SUBJECT: Site Plan Review for 5581 Hudson Industrial Parkway – Universal Screen Arts

PC Case No: 2016-18

Re: **Universal Screen Arts Building Expansion**

2016 Screen Print Expansion for UNIVERSAL SCREEN ARTS
 Hudson, Ohio

DRAWN BY:GA
 CHECKED BY:JG
 SCALE:1"= 20'-0"
 DATE: JUNE, 2016
 DRAWING NO.
C-1

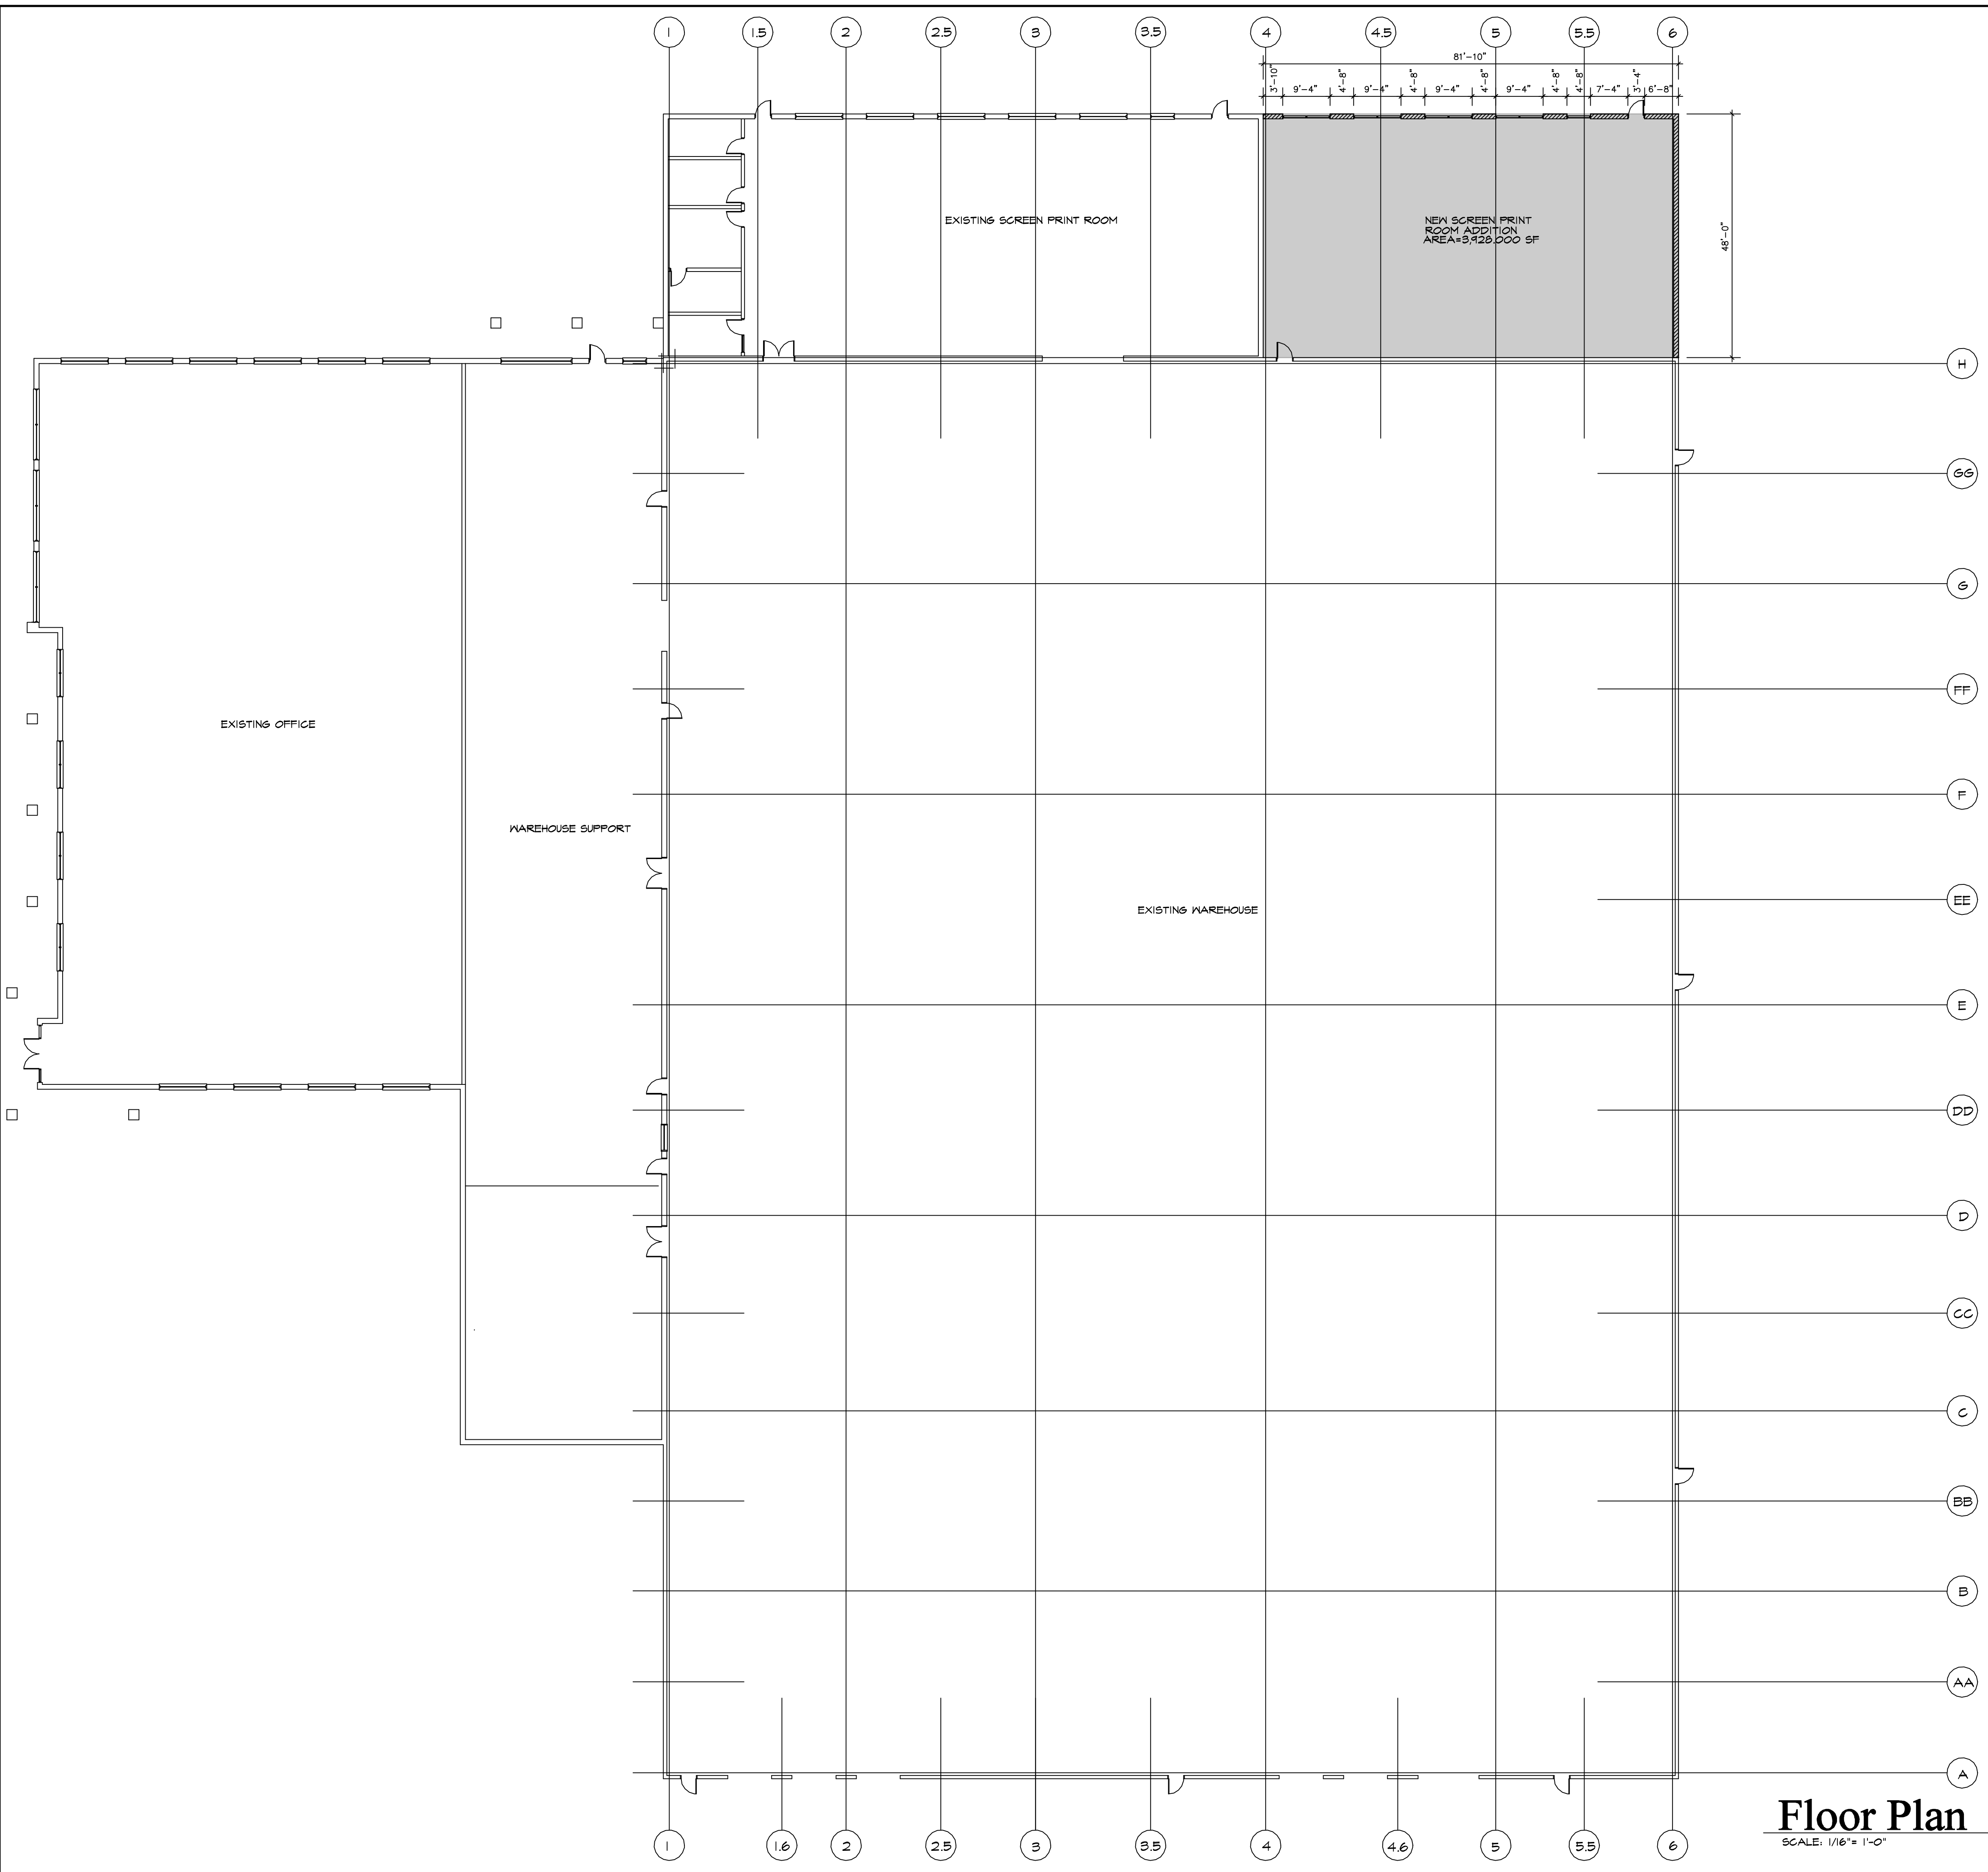
Wetlands and a stream corridor are located to the north of the development, outside of the project limits. Staff does not anticipate any impact to applicable setbacks; however, the grading design must be revised to depict a larger portion of the property and demonstrate the grading will not encroach into the existing tree line.

The site presently contains a large gravel area to the rear of the building. This surface was installed in 2006, without initial authorization from the City, to meet temporary parking demands. At that time, The City of Hudson requested the property owner comply with the LDC requirements including the need for site plan approval and a paved surface or to remove the installation. As part of the 2016 subject application this area will be largely removed and returned to a grass cover. A 45 foot wide fire access road with 28 parking stalls are proposed to remain adjacent to the east side of the building. The fire access road is acceptable to remain as a gravel surface; however, Section 1207.04(o) of the LDC requires parking areas to contain a paved surface. Staff requests the area contain an asphalt or concrete pavement or the proposed parking stall markings be removed from the plans.

- Provide pre and post impervious surface area on plan sheet per Hudson Engineering Standards Section 1.7.
- Provide the existing depth of the gravel parking area on the plan to be replaced with topsoil. If the gravel is to remain, provide the construction method that will be used to loosen the gravel (tilling, etc..) and allow it to be mixed with the proposed topsoil to reduce its imperviousness.
- Provide the proposed depth of the topsoil (Hudson min. 4" of screened topsoil, no clay backfill). More topsoil may be necessary to cover the gravel for cosmetic purposes.
- Please confirm that no impact to the existing wetland areas on north side of addition will be impacted as part of this project.

- Signage stating *Fire Lane – No Parking* must be installed in approved locations to clearly identify the fire apparatus access drive to the proposed addition as a fire lane:
 - East side of fire apparatus access drive
 - Turnaround area at the north end of the fire apparatus access drive

1. The comments of City Engineer Thom Sheridan must be addressed per the July 5, 2016 correspondence.
2. Staff requests the rear gravel parking area be revised to comply with LDC Section 1207.12(o) by incorporating an asphalt or concrete pavement or removing the parking stalls.
